**SUBJECT: COMANCHE PEAK STEAM ELECTRIC STATION (CPSSES)
DOCKET NOS. 50-445 AND 50-446
RESPONSE TO REQUEST FOR ADDITIONAL INFORMATION
RELATED TO LICENSE AMENDMENT REQUEST 05-007,
REVISION TO TECHNICAL SPECIFICATION 5.6.6 REGARDING
PRESSURE AND TEMPERATURE LIMITS REPORT (PTLR)
TAC NOS. MC9500 AND MC9501**

**TXU POWER RESPONSE TO
REQUEST FOR ADDITIONAL INFORMATION**

**LICENSE AMENDMENT REQUEST 05-007
REVISION TO TECHNICAL SPECIFICATION 5.6.6 REGARDING
PRESSURE AND TEMPERATURE LIMITS REPORT (PTLR)
COMANCHE PEAK UNITS 1 AND 2
TXU GENERATION COMPANY, LP
TAC NOS. MC9500 AND MC9501**

**COMANCHE PEAK STEAM ELECTRIC STATION (CPSES)
PRESSURE AND TEMPERATURE LIMITS REPORT
(APPLICABLE UP TO 36 EFPY)**

Figure 2-1 Reactor Coolant System Heatup Limitations for CPSES Unit 1 and Unit 2 -
Applicable for the First 36 EFPY

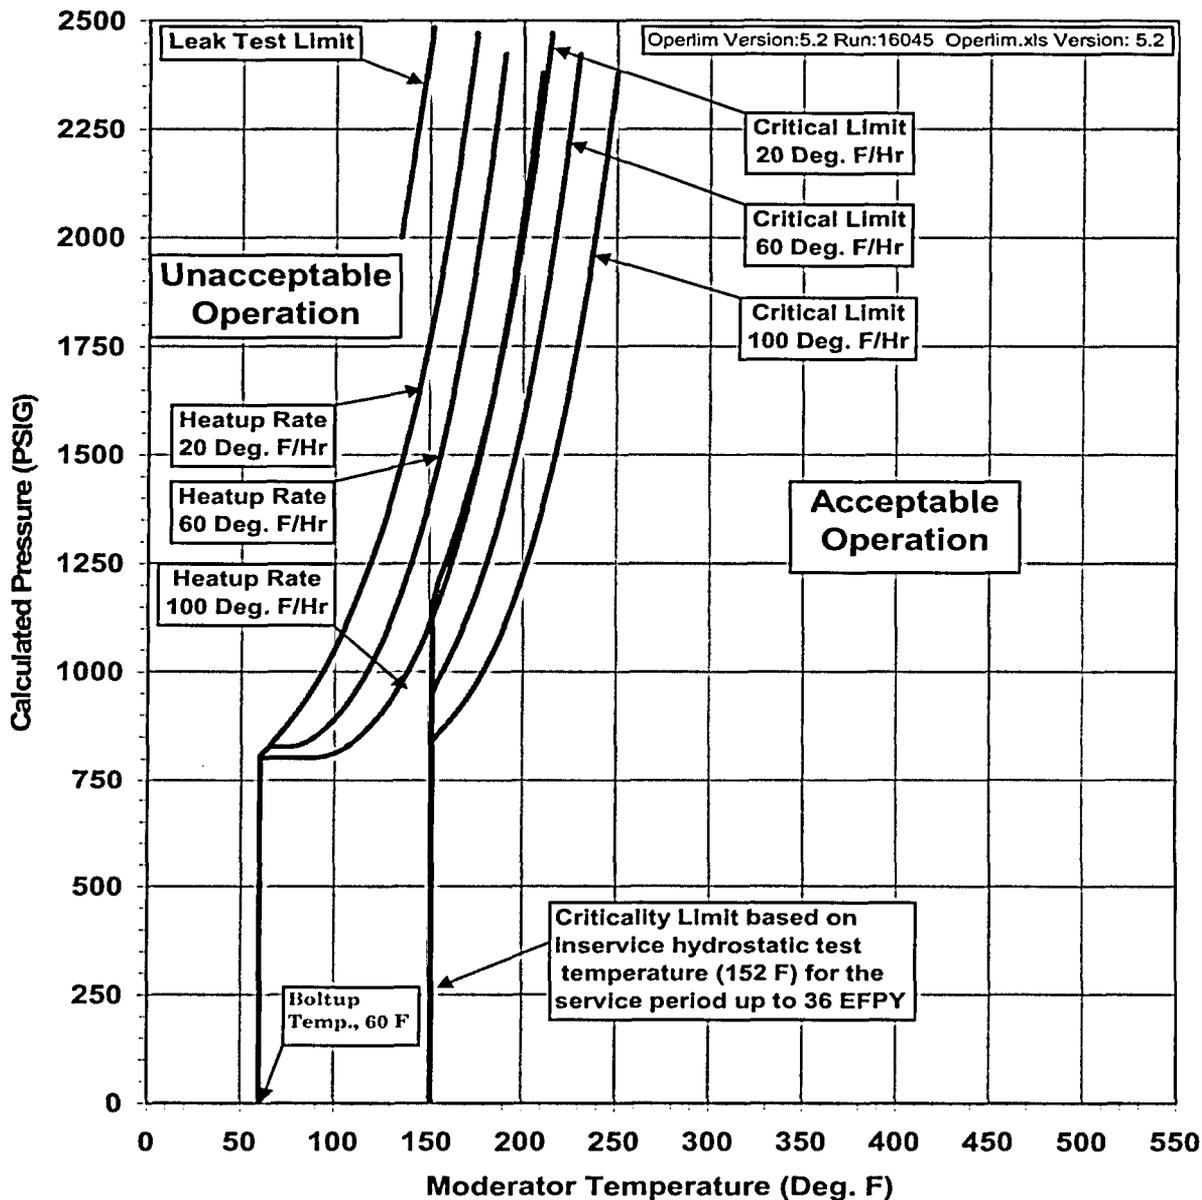
Generic Letter (GL) 96-03 requires that: (1) a PTLR shall identify both the limiting adjusted reference temperature (ART) values and limiting materials at the 1/4t and 3/4t locations and (2) a PTLR for pressurized water reactors (PWRs) shall identify the reactor pressure vessel's (RPV's) limiting reference temperature (RTPTS) value in accordance with Title 10 of Code of Federal Regulations Part 50, 50.61. Please revise your PTLR to include the limiting ART values and limiting materials at the 1/4t and 3/4t locations for Unit 2. Further, the RPV's limiting RTPTS values for both units shall also be included in the PTLR. Lastly, it appears that you propose to use one set of pressure-temperature (P/T) limits to bound those for both units. If this is the case, a footnote on PTLR Figures 2-1 and 2-2 to indicate this approach would clarify your intention.

- (1) The revised PTLR, attached to these responses, identifies the limiting ART value and material at the 1/4t and 3/4t locations for each reactor vessel.
- (2) The RTPTS values and bases for each unit are included in the revised PTLR, attached to these responses.
- (3) An appropriate notation to include the suggested information has been added to Figures 2-1 and 2-2 of the revised PTLR, included with these responses.
